2 REDLINE REVISION NO. 2
2008
Jennifer M. Brindle 9/21/2008

TRAFFIC SIGNAL PLAN
MD 140 (E. BALTIMORE ST) AND CHEVRO DRIVE/GRAND DRIVE
TANEYTOWN, MARYLAND

DRAWING NO. 3440B — SHEET NO. 204 OF

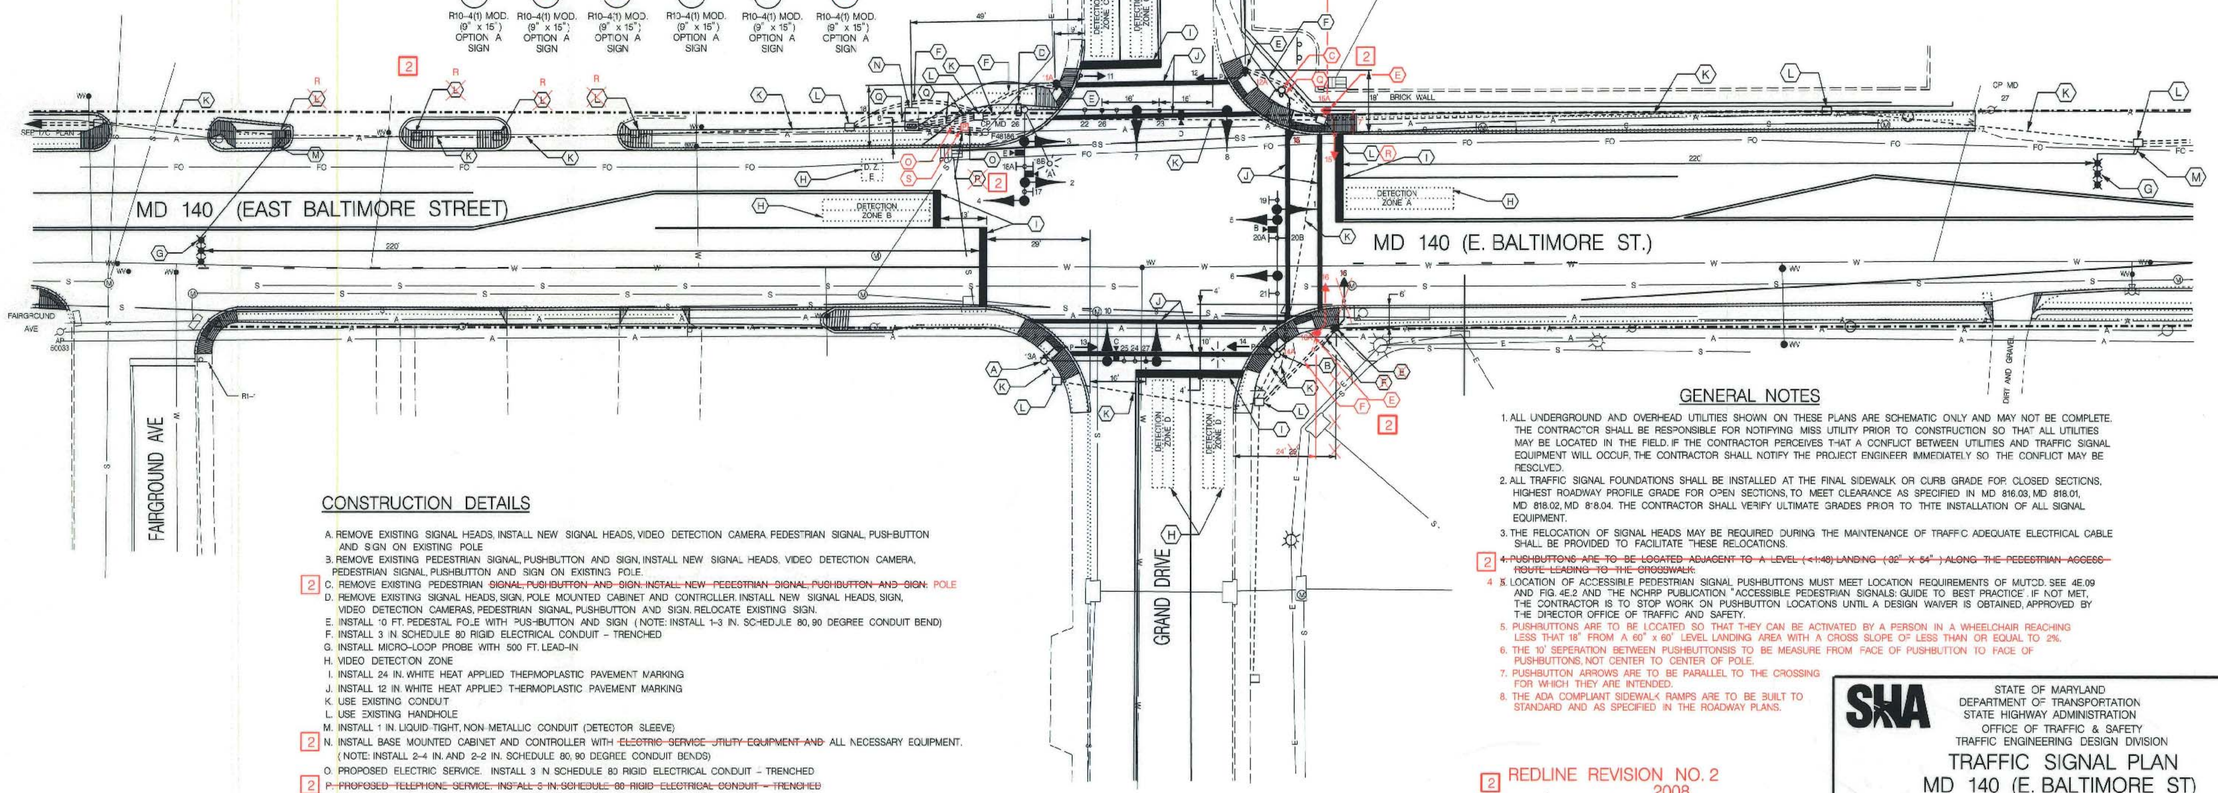
2 C. REMOVE EXISTING PEDESTRIAN ~~SIGNAL, PUSHBUTTON AND SIGN. INSTALL NEW PEDESTRIAN SIGNAL, PUSHBUTTON AND SIGN.~~ POLE

2 N. INSTALL BASE MOUNTED CABINET AND CONTROLLER WITH ~~ELECTRIC SERVICE, UTILITY EQUIPMENT AND~~ ALL NECESSARY EQUIPMENT. (NOTE: INSTALL 2-4 IN. AND 2-2 IN. SCHEDULE 80, 90 DEGREE CONDUIT BENDS)

2 ~~P. PROPOSED TELEPHONE SERVICE. INSTALL 3 IN SCHEDULE 80 RIGID ELECTRICAL CONDUIT - TRENCHED~~

2 R. ADJUST EXISTING HANDHOLE FRAME AND COVER TO FINAL GRADE

2 ~~4. PUSHBUTTONS ARE TO BE LOCATED ADJACENT TO A LEVEL (<1:48) LANDING (32" X 54") ALONG THE PEDESTRIAN ACCESS ROUTE LEADING TO THE CROSSWALK.~~

4 5. LOCATION OF ACCESSIBLE PEDESTRIAN SIGNAL PUSHBUTTONS MUST MEET LOCATION REQUIREMENTS OF MUTCD. SEE 4E.09 AND FIG. 4E.2 AND THE NCHRP PUBLICATION "ACCESSIBLE PEDESTRIAN SIGNALS: GUIDE TO BEST PRACTICE". IF NOT MET, THE CONTRACTOR IS TO STOP WORK ON PUSHBUTTON LOCATIONS UNTIL A DESIGN WAIVER IS OBTAINED, APPROVED BY THE DIRECTOR OFFICE OF TRAFFIC AND SAFETY.
